## 10.4 Other Features of Steam and Power Conversion

The information in this section of the reference ABWR DCD, including all subsections, tables, and figures is incorporated by reference with the following departures and supplements.

Figure 10.4-1 Main Condenser Evacuation System

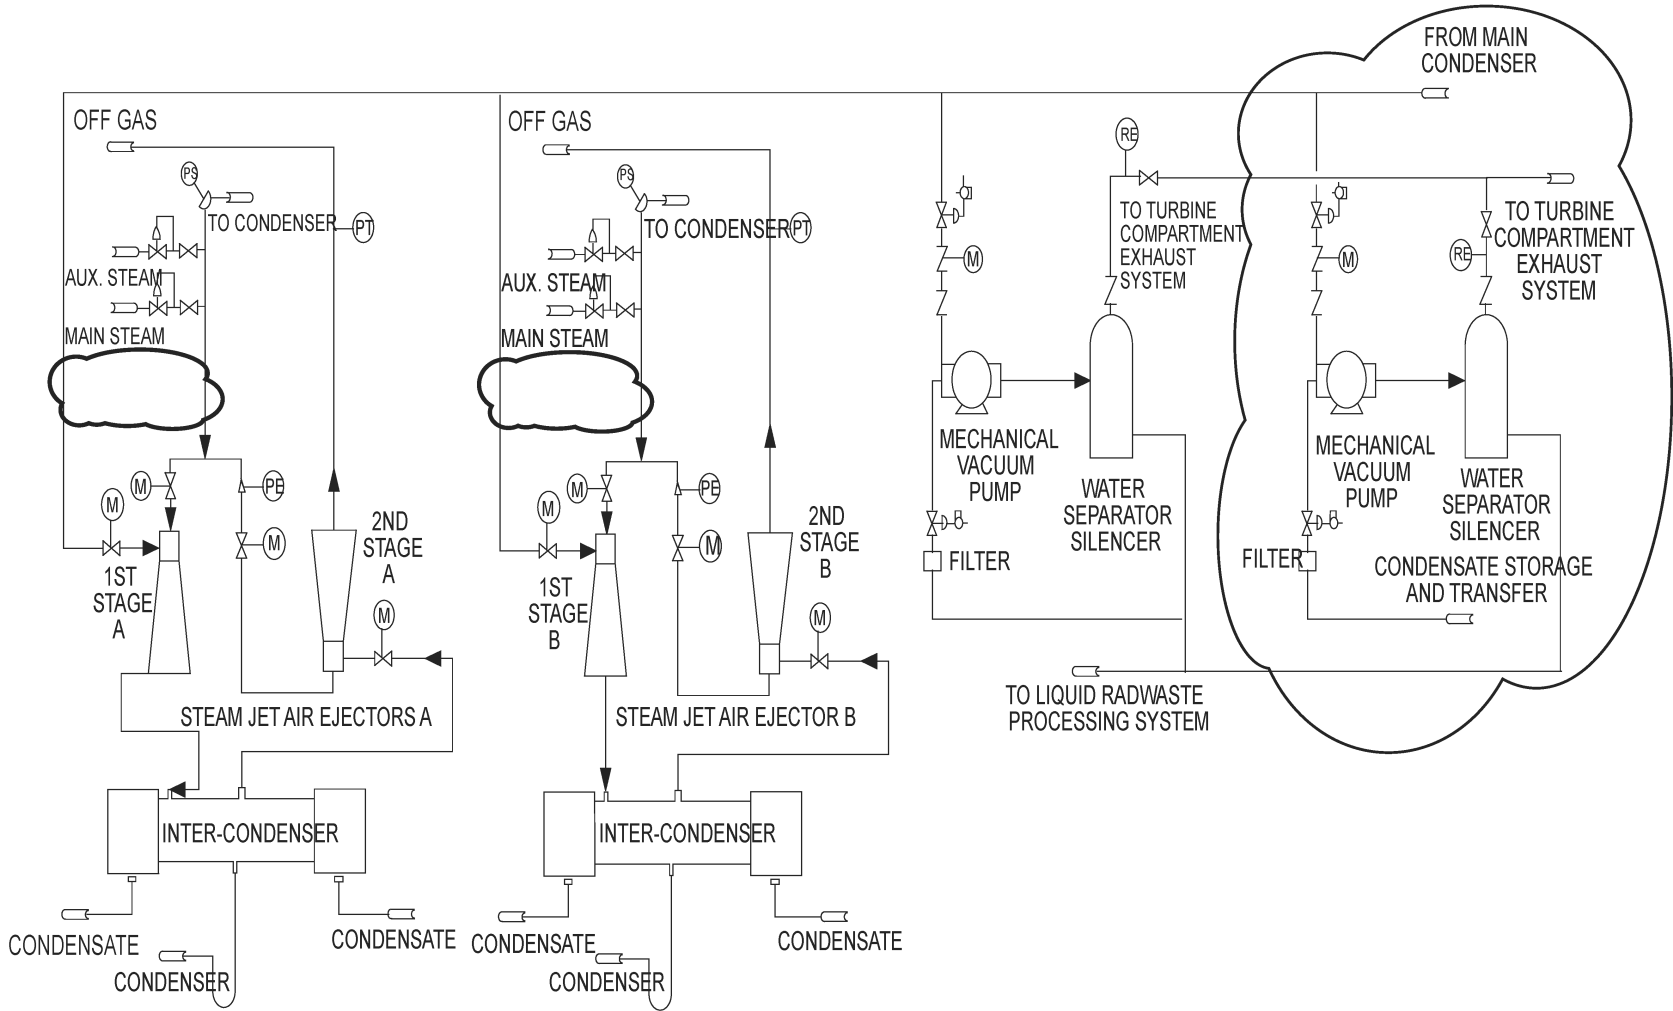
STP DEP 10.4-3 (Table 10.4-2, Figure 10.4-1)

*The MCES (figure 10.4-1) consists of two 100%-capacity, double stage, steam jet air ejector (SJAE) units (complete with ~~intercondenser~~ intercondensers) for power plant operation, and a ~~two, 100% mechanical vacuum pump~~ pumps for use during startup.*

During normal power operations, the SJAEs are ~~normally~~ driven by ~~crossaround steam, with the main steam supply on automatic standby. The main steam supply, however, is normally used during startup and low load operation, and auxiliary~~ Auxiliary steam is available for normal use of the SJAEs during early startup, should the mechanical vacuum ~~pump pumps~~ prove to be unavailable.

The vacuum ~~pump pumps~~ is are tripped and ~~is~~ their discharge ~~valve~~ valves is are closed upon receiving a main steam high-high radiation signal.

Figure 10.4-2 Turbine Gland Seal System

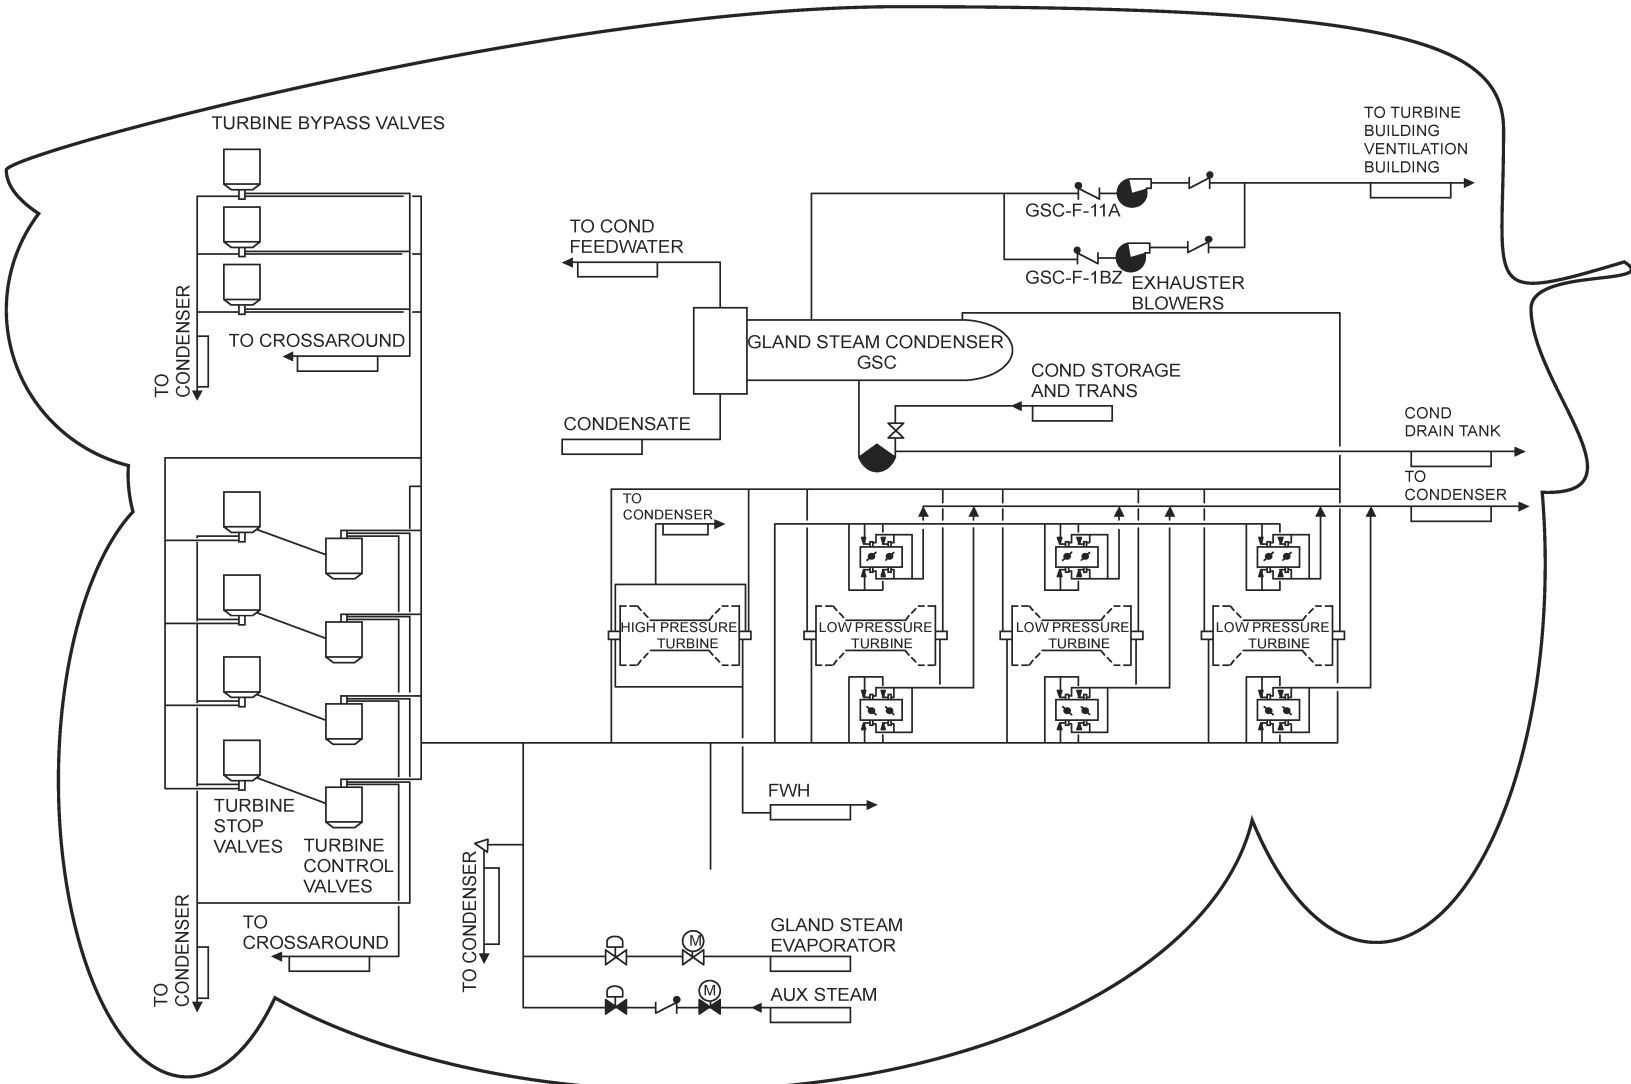
STD DEP 10.4-1 (Figure 10.4-2)

The turbine gland seal system is illustrated in Figure 10.4-2. The turbine gland seal system consists of a gland steam evaporator, sealing steam pressure regulator, sealing steam header, a gland steam condenser with two full-capacity exhauster blowers, and the associated piping, valves and instrumentation.

Figure 10.4-3 Circulating Water System

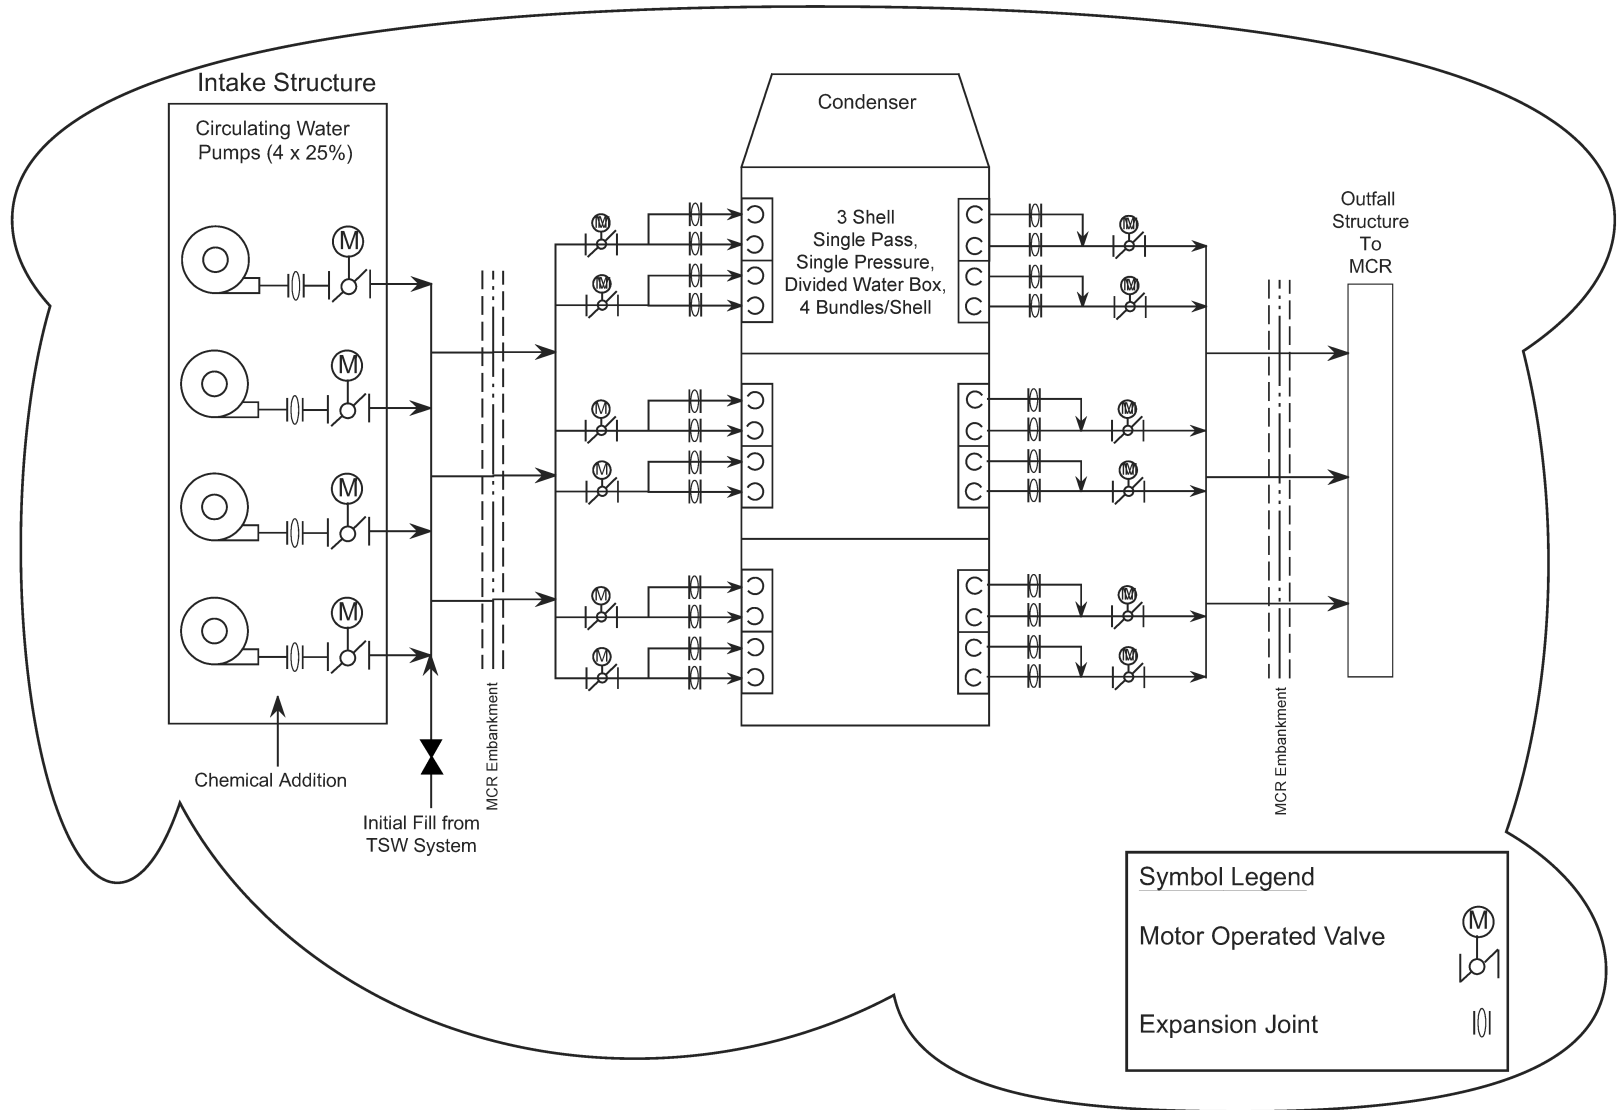
STP DEP 10.4-2 (Table 10.4-1, Table 10.4-3, Figure 10.4-3)

*~~The three condenser shells are designated as the low pressure shell, the intermediate pressure shell, and the high pressure shell.~~ The three condenser shells are cross-connected to equalize pressure. Each shell has at least two tube bundles. Circulating water flows in ~~series~~ parallel through the three single-pass shells (Figure 10.4-3).*

*The Circulating Water System (Figure 10.4-3) consists of the following components: (1) ~~screen house intake structure and intake screens, pumps,~~ (2) condenser water boxes and piping and valves, (3) tube side of the main condenser, (4) water box fill and drain subsystem, and (5) related support facilities such as for system water treatment, inventory blowdown and general maintenance.*

*The cooling water is circulated by ~~at least three~~ four 25% capacity fixed speed motor-driven pumps per unit.*

Four 25% capacity fixed speed circulating water pumps per unit discharge into a common header shown in Figure 10.4-3. The discharge of each pump is fitted with a motor operated butterfly valve. The circulating water is pumped through the main condenser and back to the MCR via a discharge outfall at a nominal rate of 272,550 m<sup>3</sup>/h per unit. To provide capability for condenser waterbox isolation, isolation valves are located on the circulating water inlet and outlet lines.

Figure 10.4-4 Condensate Purification System

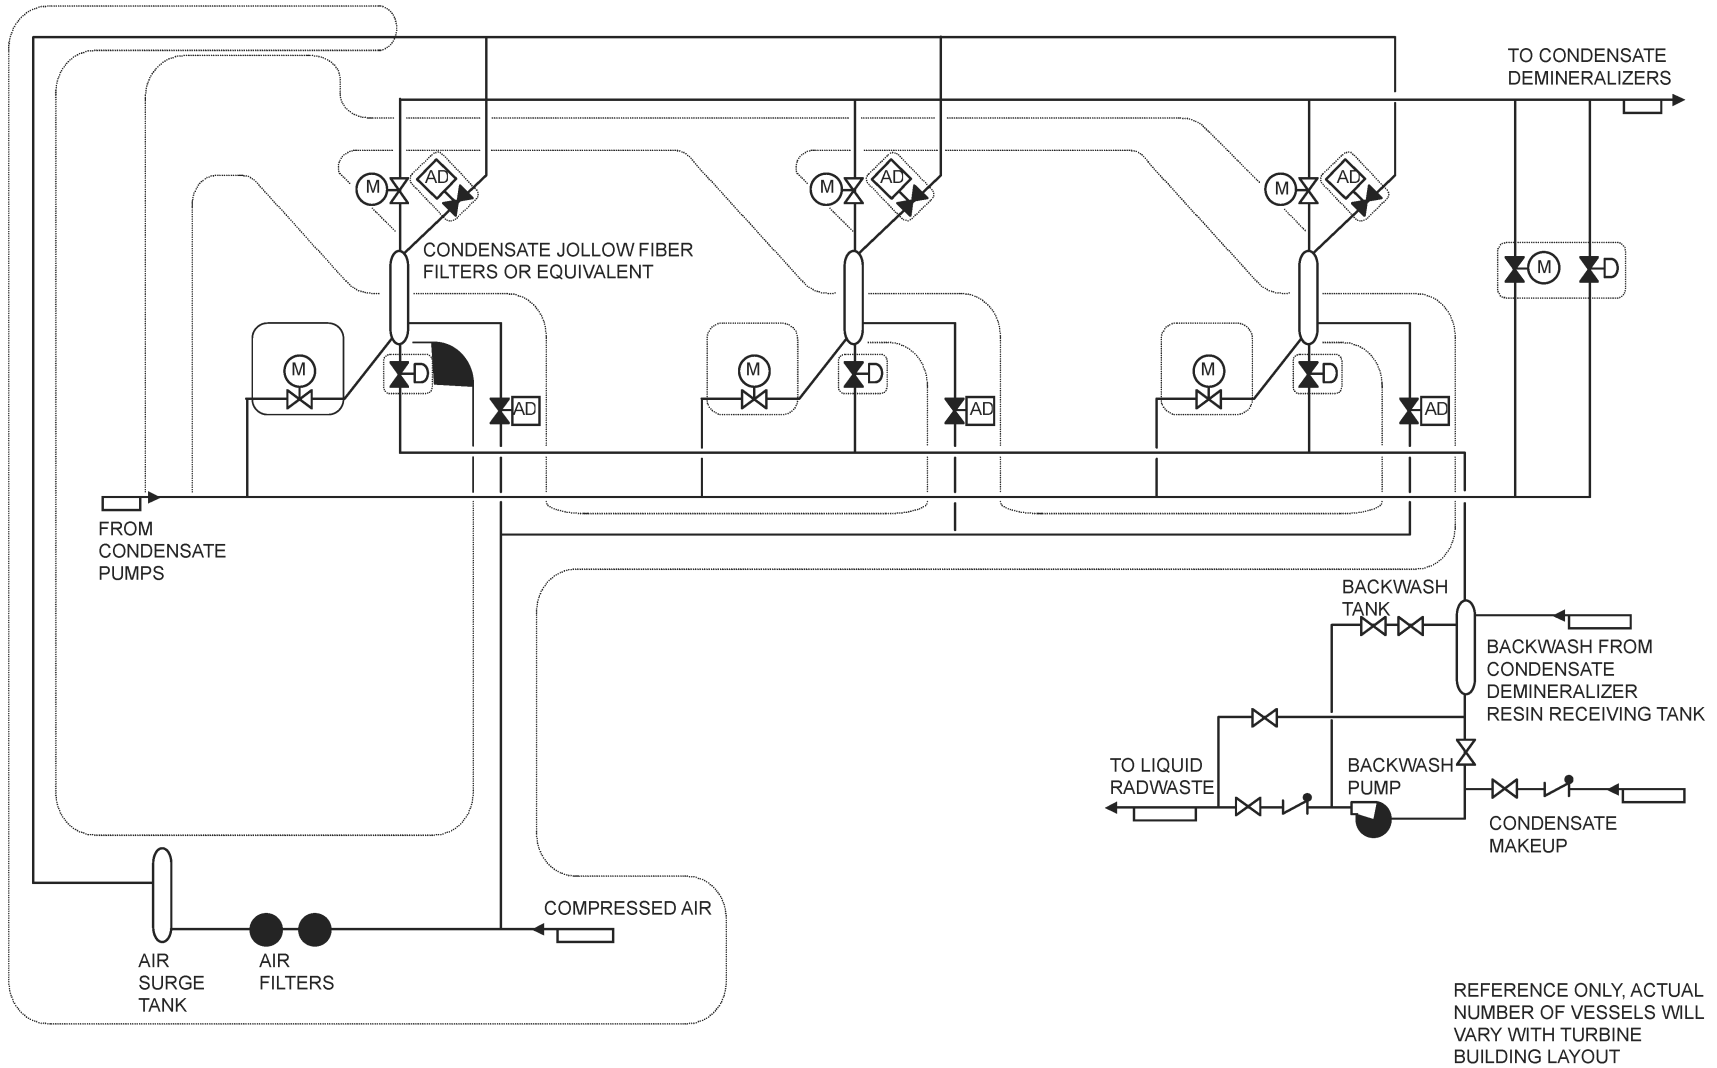
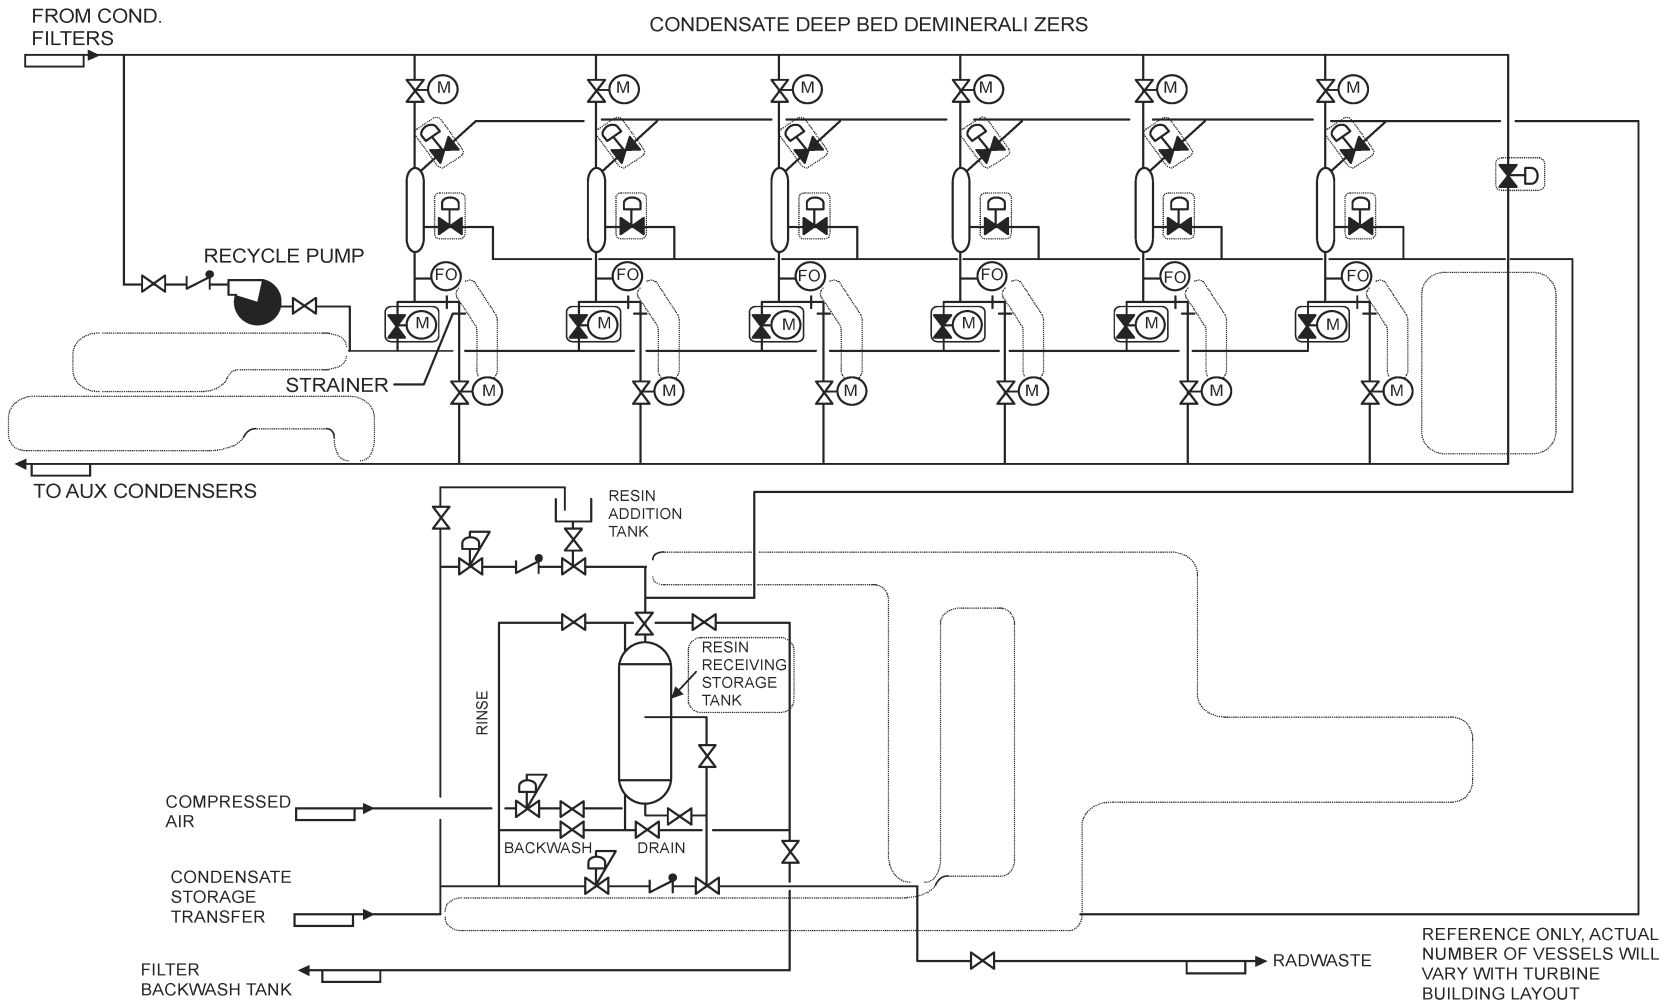
STP DEP 10.4-4 (Table 10.4-4, Figure 10.4-4)

The Condensate Purification System (Figure 10.4-4) consists of at least three high efficiency filters arranged in parallel and operated in conjunction with a normally closed filter bypass. The CPS also includes at least six bead resin, mixed bed ion exchange demineralizer vessels arranged in parallel with ~~all six~~ normally ~~at least five~~ in operation ~~and one in standby~~. A strainer is installed downstream of each demineralizer vessel to preclude gross resin leakage into the power cycle in case of vessel underdrain failure, and to catch resin fine leakage as much as possible. The design basis for the CPS system will be to achieve the water quality effluent conditions defined in a water quality specification. The CPS components are located in the Turbine Building.

Provisions are included to permit air scrub cleaning and replacement of the ion exchange resin. Each of the demineralizer vessels has ~~fail-open~~ "as-is" inlet and outlet isolation valves which are remotely controlled from the local CPS control panel.
